Re: Initial Submission Review – Pomeroy FDP Amendment
Application Number: **DA-1670-01**
Case Numbers: **2002-7004-01**

Initial Submission Review

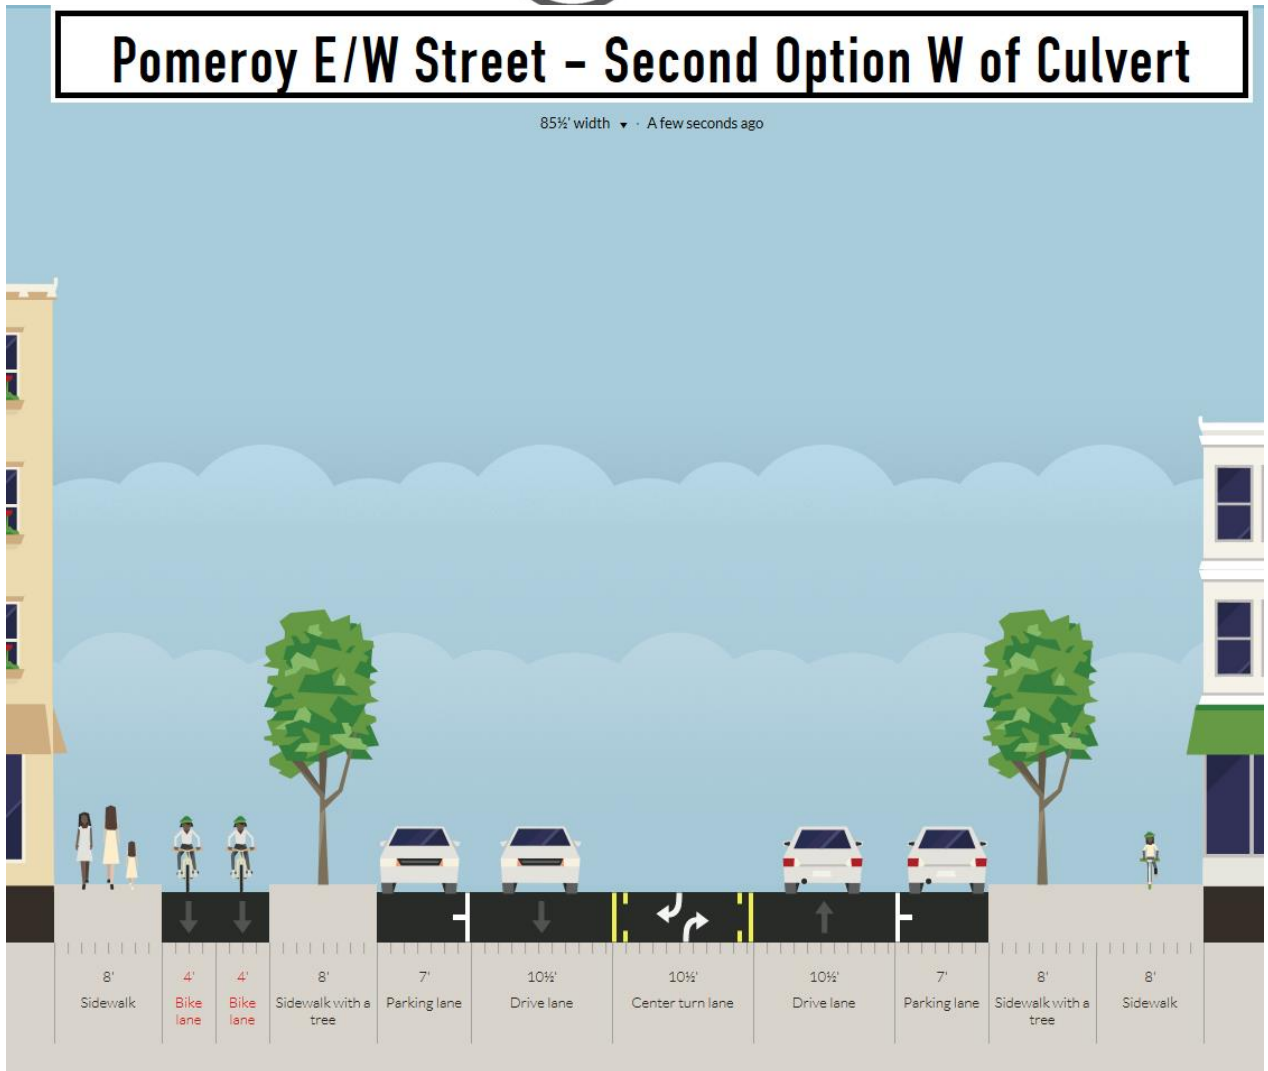
- See redline comments on Form J for further clarification
- Due to the change in street cross section removing on-street bike facilities, alternate facilities must be provided to achieve connectivity:

The preferred route is a minimum 8-foot wide multiuse trail running along the south side of the property, curving with the road to intersect at the signalized intersection. The secondary route is to provide an 8-foot wide separated, bi-directional bike facility on the south side of the street. If this option is preferred, please contact me and we can work through design specifications according to the [FHWA separated bikeway](#) guide.

Both options may provide a single 10-foot mixed-use crossing of the drainage channel

Pomery E/W Street – W of Culver Opt1

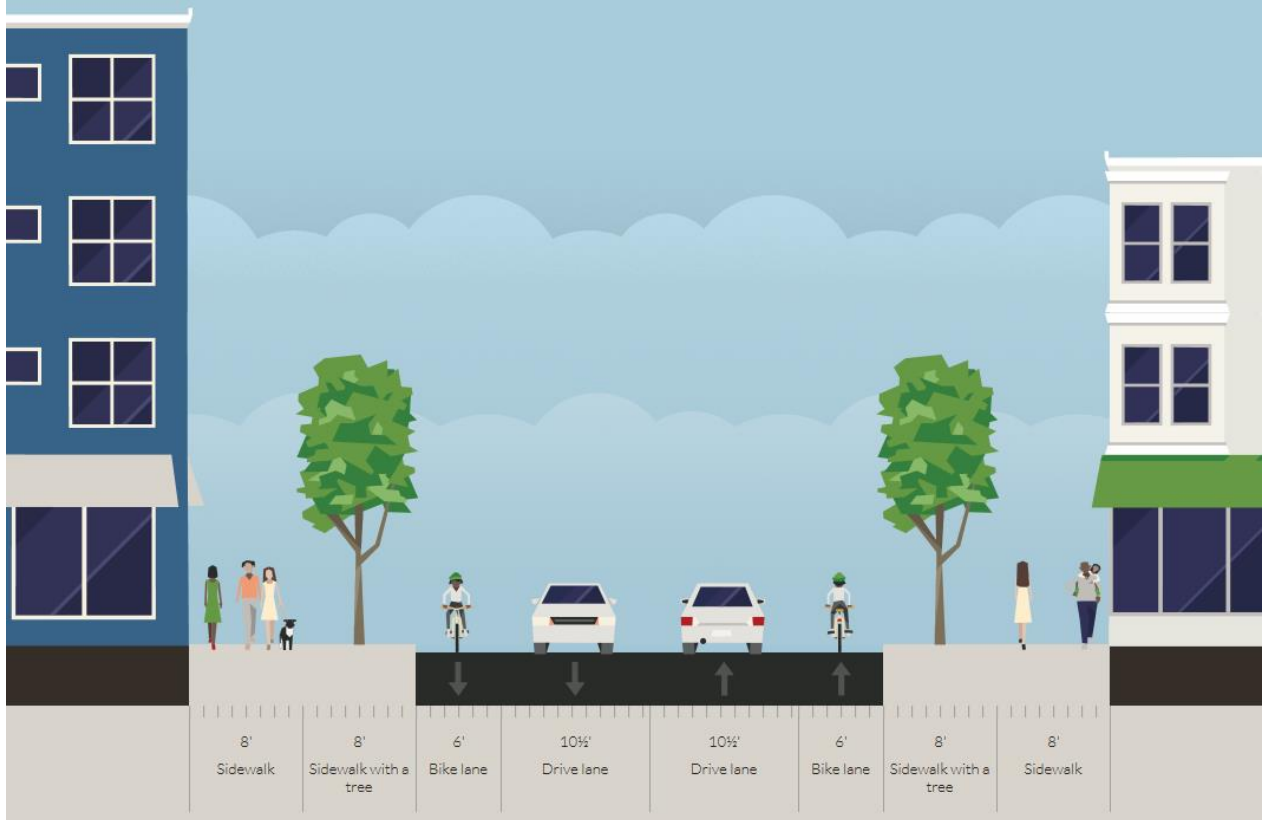
An enhanced crossing of the east/west street on the east side of the culvert is required. Consider the use of a raised intersection, [RRFB](#), and/or enhanced crosswalk treatment (see below). Ensure the crossing distance is as short as possible.

The cross section west of the culvert has a couple different opportunities to provide appropriate access for people utilizing automobiles, bikes, or walking.

- One option is to eliminate the turn lane to calm traffic and provide on-street bike lanes. With this option, more curb cuts would be allowed to provide greater residential access and give the residential properties a greater street presence, but on-street parking would be disallowed due to the frequency of the curb cuts. Therefore, providing an on-street bike lane will be possible.

Pomery E/W Street – W of Culver Opt2

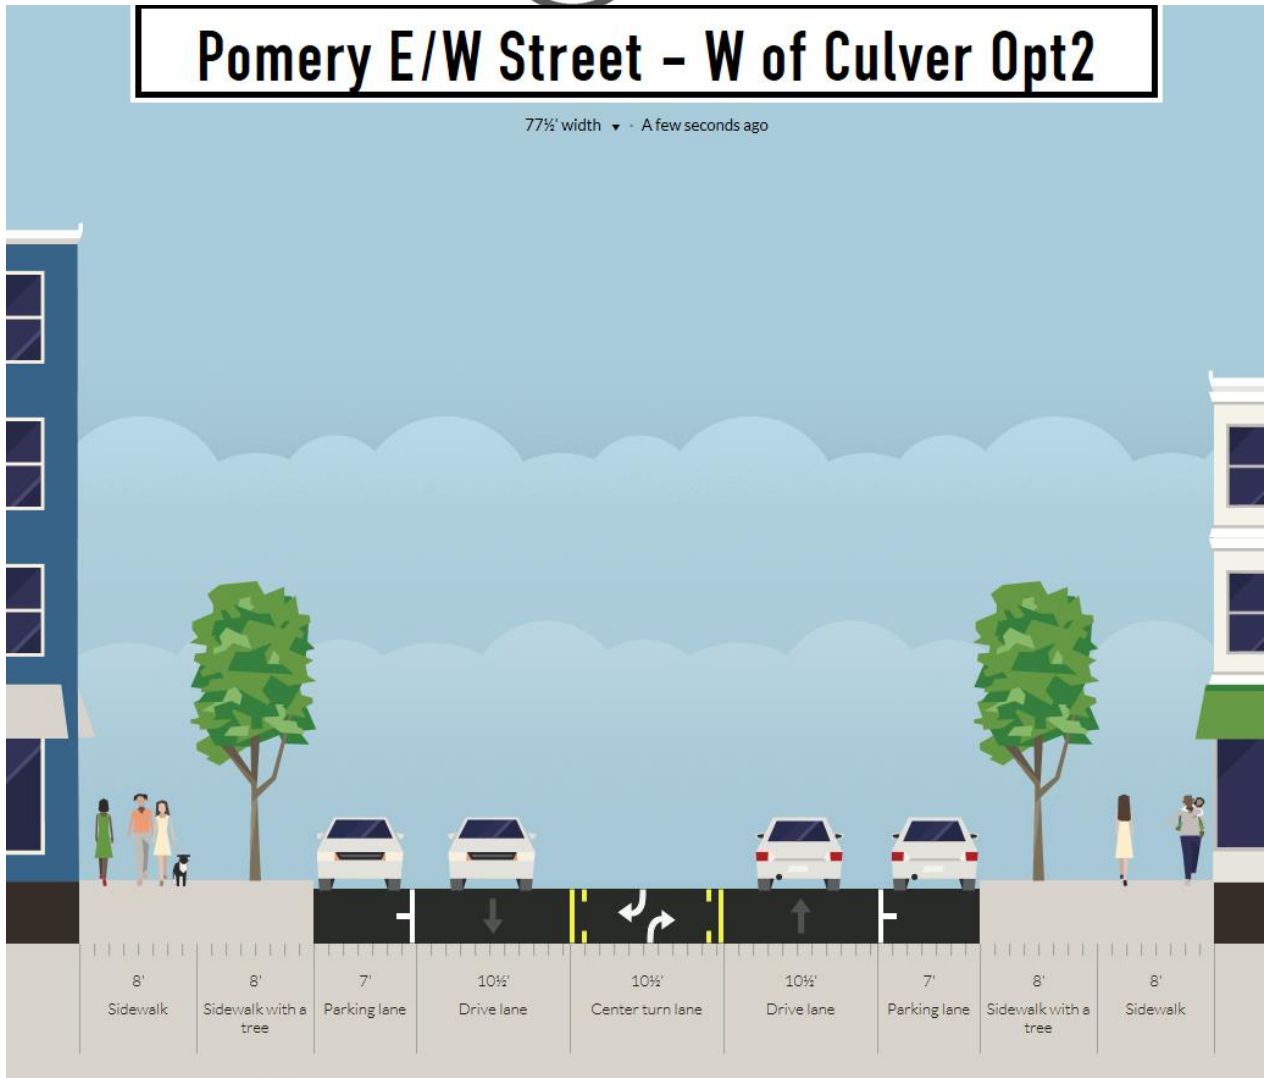
A second option is to provide a wider cross section to include on-street parking and a two way left turn lane. This will require fewer curb cuts providing access to the multifamily building. The fewer curb cuts will result in longer queues to access the residential properties, requiring the center turn lane, but on-street parking will be able to be provided between access points. In this alternative, please provide curb bulb outs at driveways and intersections to reduce the pedestrian crossing distance of the street.

Pomery E/W Street - W of Culver Opt2 @ Intersectio...

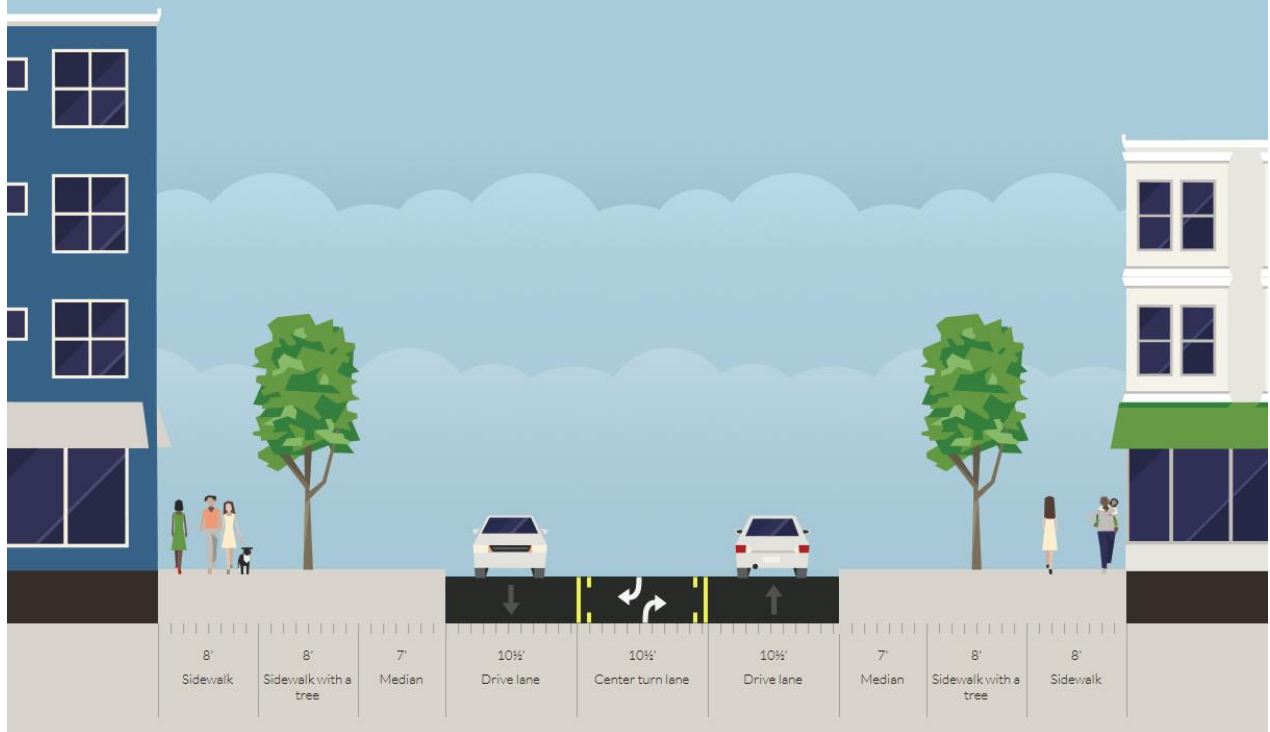
The cross section depicted on the next page reflects the same cross section as “Pomeroy E/W Street – W of Culvert Opt2” but illustrates the intersection treatment. Intersections of this cross section will be lined with curb extensions to reduce the overall pedestrian crossing distance of intersections or driveways and improve sight lines for turning vehicles.
